Model : Saddle Finisher-D2

Ref. No. : FF-T01-W-000090-01

Location : MAIN UNIT INTERIOR (2) / PUNCH ASSEMBLY / FINISHER CONTROLLER PCB

Subject : REDUCTION OF SOUND WHEN SIDE REGISTRATION OF PUNCH UNIT IS IN OPERATION

Fig. 1

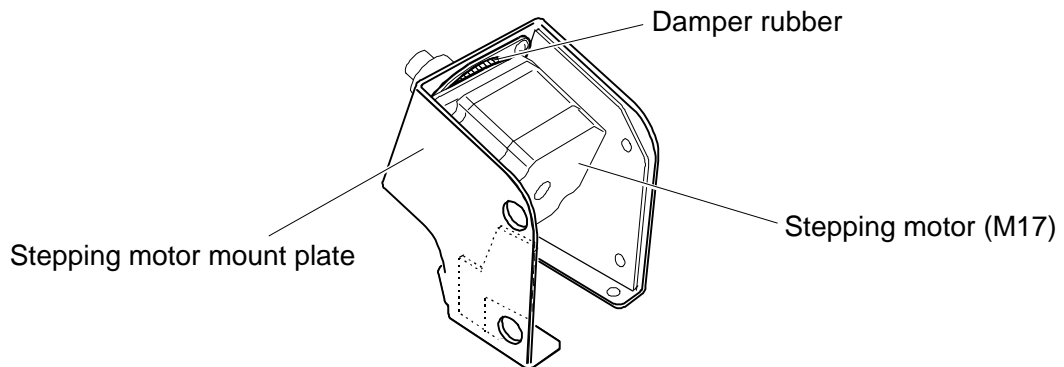
1. As procedures to handle causes 1 and 2, the versions of the master ROM and slave CPU will be upgraded along with a change to the stepping motor unit.
 - 1-1. The stepping motor unit will be changed as follows. This change will serve to keep stepping motor (M17) vibration in check.
 - The hardness of the stepping motor's (M17) damper rubber will be lowered, resulting in absorption of vibrations (Fig 1).
 - A vibration-absorbing paint will be added to the stepping motor's (M17) mount plate (Fig 1).

- Servicing** : If the above symptoms occur, put the following 3 procedures into effect.
1. Replace the stepping motor unit with a new one.
 2. Replace the punch slide unit punch left cover with a new one.
 3. Simultaneously upgrade the master ROM (IC105) and the slave CPU (IC121) from Ver. 3 to at least Ver. 4.

Fig. 2

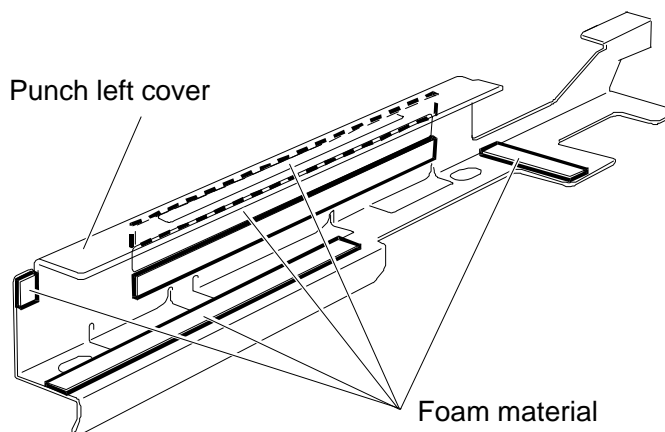
2. As the procedure to handle cause 3, foam material will be added to 5 locations on the punch slide unit punch left cover (Fig 2). This change will reduce the slight noise in the punch slide unit.
